Memorandum

To: Rick Bondar
 From: Jason Ardery
 Date: February 25, 2016
 Re: RTRP Conflict Areas with Sky Country Investment Co./East, LLC (APNs: 160-050-023 & -031)

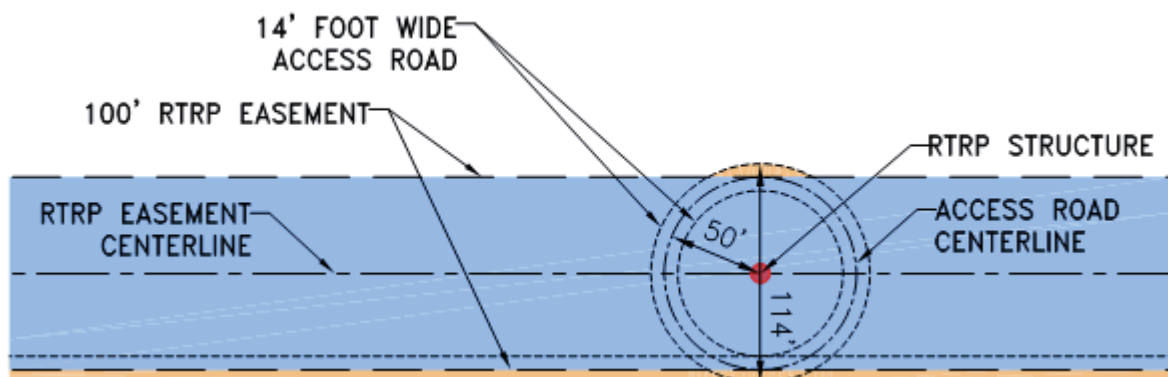
Sky Country Investment Co./East, LLC owns approximately 65.3 acres north of Limonite Avenue, adjacent to the I-15 Freeway, depicted in the attached exhibit. Based on the proposed alignment of the RTRP project, there will be significant impacts to this property:

1. The area is currently planned for Commercial, Industrial, and Residential uses per the I-15 Corridor Specific Plan (SP 266). The proposed RTRP alignment would eliminate approximately 2.9 acres of Scenic Highway Commercial (C-P-S), 1.8 acres of Industrial Park (I-P), and 1.8 acres of One-Family Dwellings (R-1) from the site, as well as leave a sliver of potentially unusable area of approximately 1.3 acres between the proposed RTRP easement and the I-15 Freeway on the southwest portion of the Scenic Highway Commercial (C-P-S) portion of the property.

2. Based on the alignment provided, encroachment into the RTRP easement would be required in order to obtain access to the 1.3 acre sliver and the three cell towers located between the proposed RTRP easement and the I-15 Freeway. Per the item number 2 of the attached "Southern California Edison Company Transmission Line Right of Way Constraints and Guidelines":

Based on this requirement, it is not clear how permanent access and utilities would be provided to the 1.3 acre sliver. Permanent access would typically include AC Pavement, curb & gutter, along with any utilities (pipelines) required to provide service to the property, and per the "Southern California Edison Company Transmission Line Right of Way Constraints and Guidelines" this is not allowed. Therefore this 1.3 acre sliver would become unusable.

3. The reduction of approximately 4.2 acres of Scenic Highway Commercial (C-P-S) will reduce the potential commercial building square footage by approximately 50,000 square feet (assumes a Floor Area Ratio of 0.275 which is the average of the allowable Building Density Commercial Retail per the General Plan = 0.2-0.35 FAR).
4. The reduction of approximately 1.8 acres of Industrial Park (I-P) will reduce the potential Industrial building square footage by approximately 32,500 square feet (assumes a Floor Area Ratio of 0.425
